EVALUATION OF PROPOSED CHANGES

Subject: Modification of the Control Room Emergency Air Treatment System (CREATS), changing of the Dose Calculation Methodology to Alternate Source Term (10CFR50.67) and revision of Ginna Technical Specification Sections 1.1, 3.3.6, 3.4.16, 3.6.6, 3.7.9, 5.5.10, 5.5.16 and 5.6.7.

This letter is a request to amend Operating License Docket # 50-244 for the R.E. Ginna Nuclear Power Plant.

Figure 1

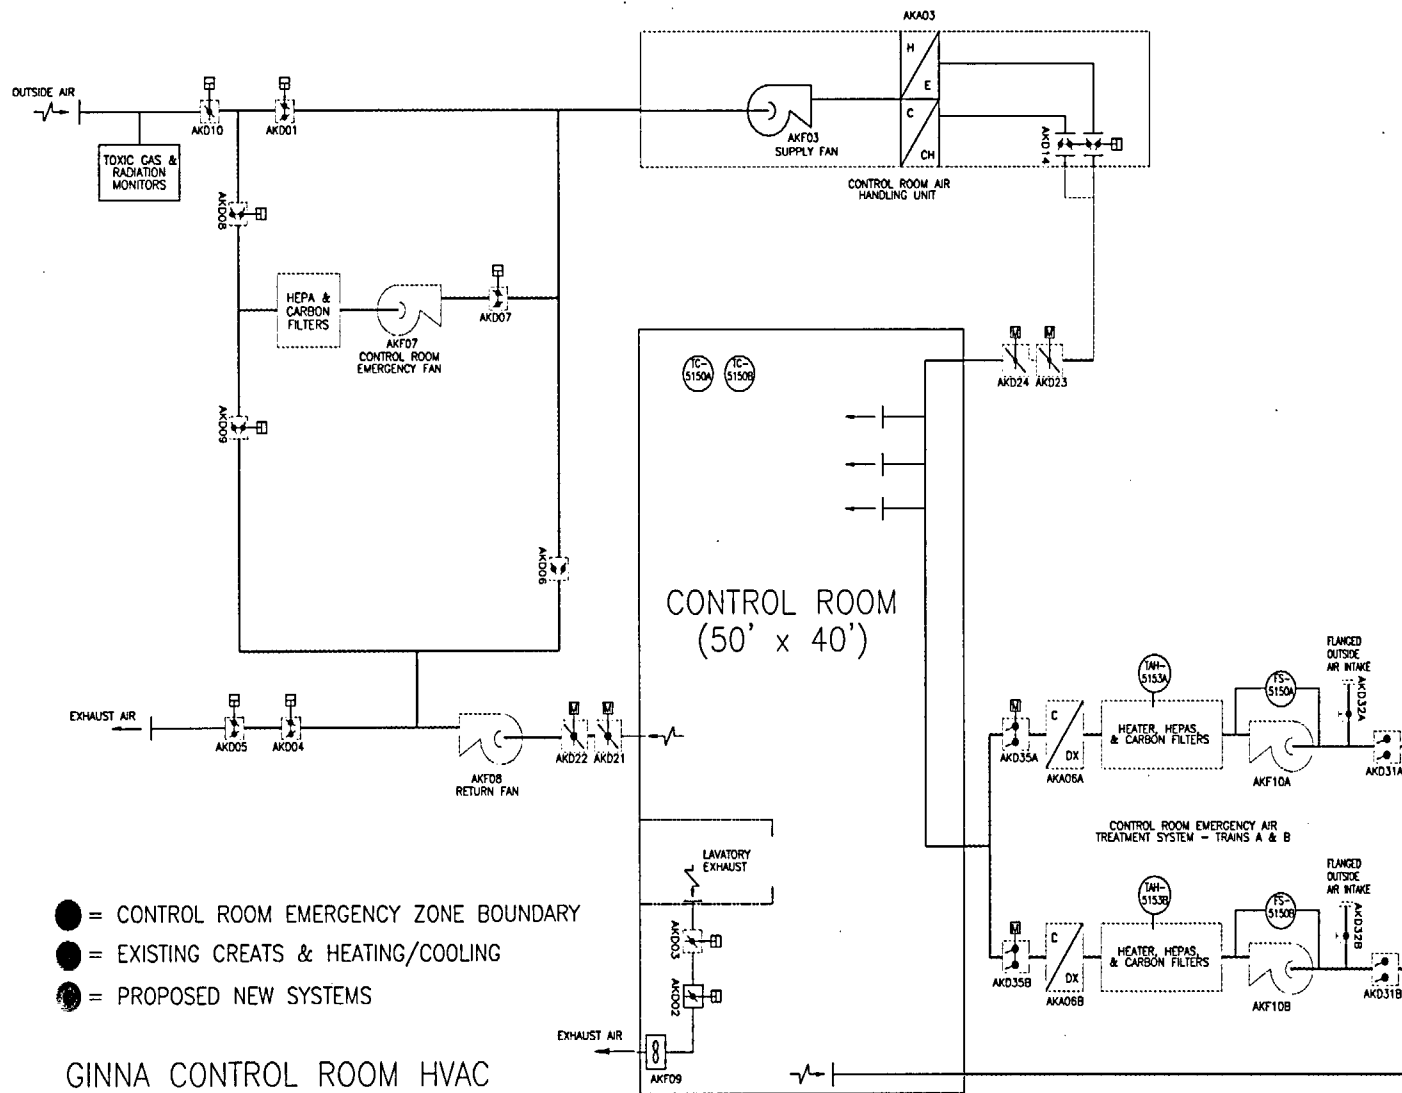
Short ducts sealed with blind flanges will be installed on the inside of the Control Room walls to provide a connection point for the interior ductwork (see A on Figure 1). Holes will then be cut from the outside of the control room wall along the internal radius of the short ducts. The interior blind flange plates will stay in place until the external system is installed and pressure tested.

Figure 3.4.16-1
Reactor Coolant DOSE EQUIVALENT I-131 Specific Activity Limit Versus Percent of RATED THERMAL POWER

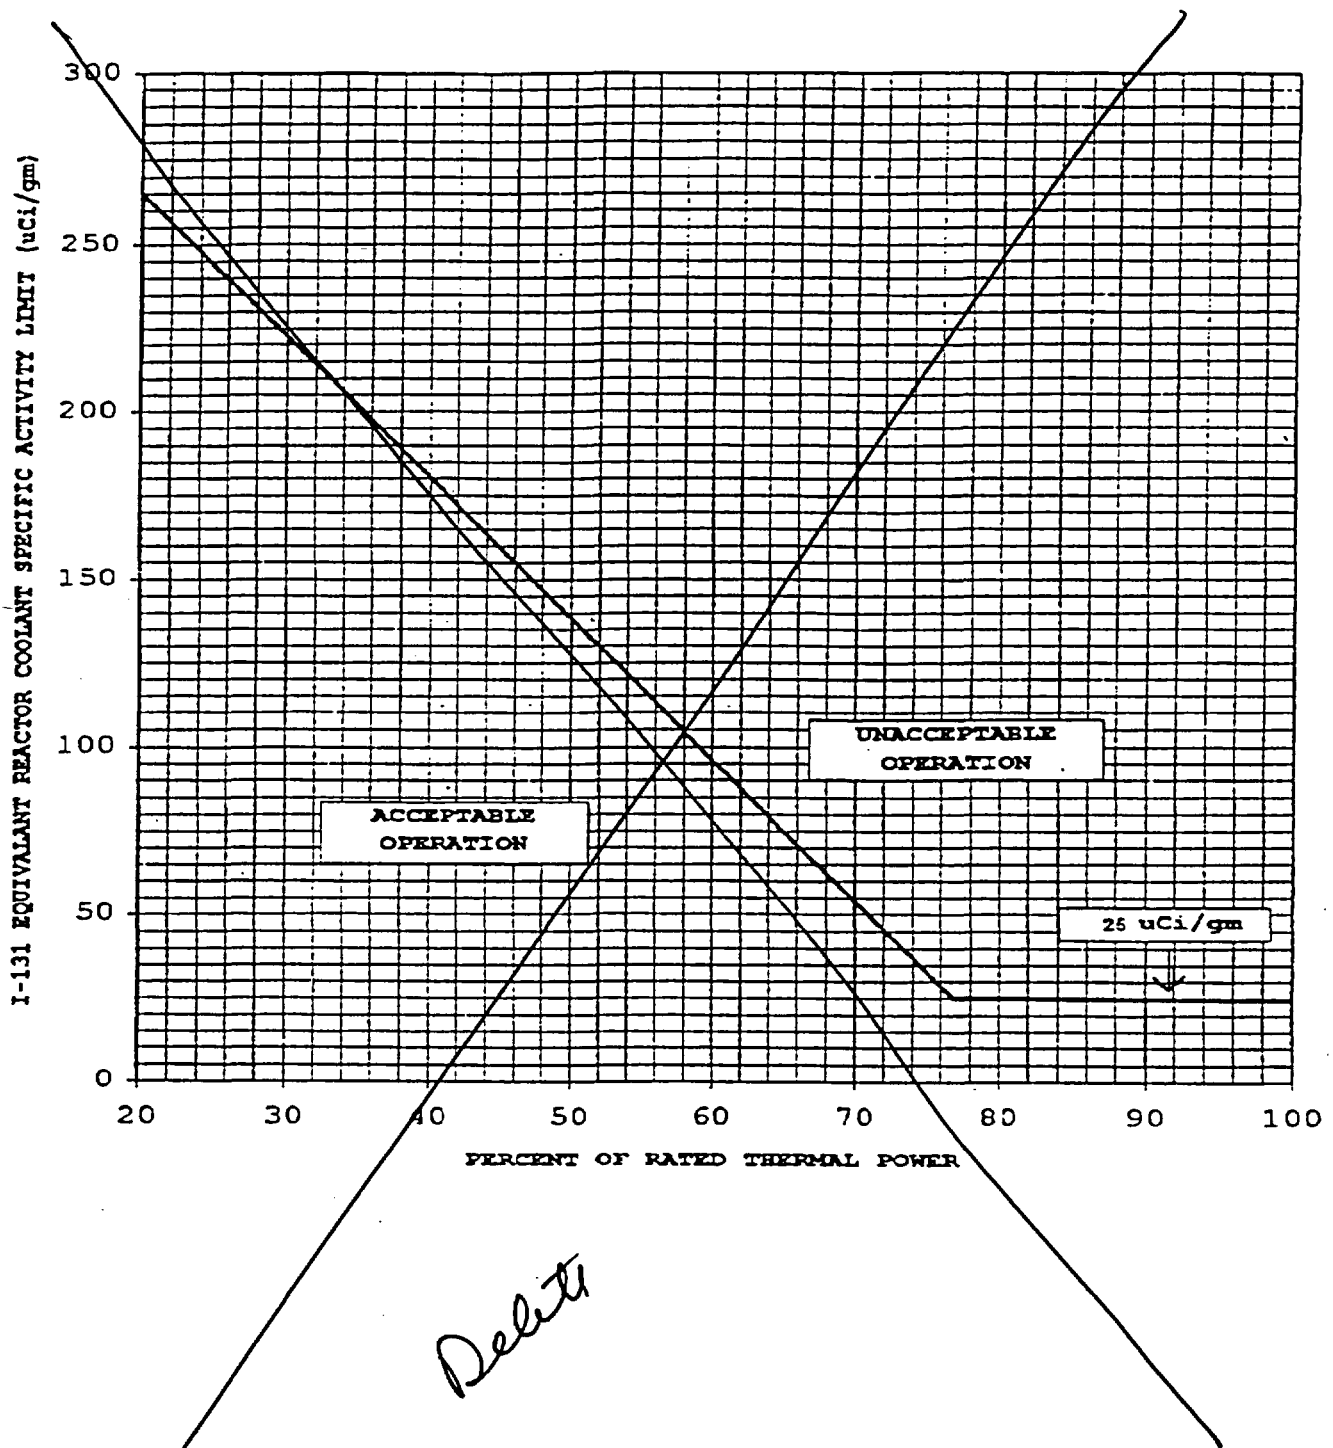
- Section 3.4.16 - RCS Specific Activity Limits will be revised to eliminate Figure 3.4.16-1 and provide a single limit for Dose Equivalent I-131 specific activity consistent with the new dose analysis.
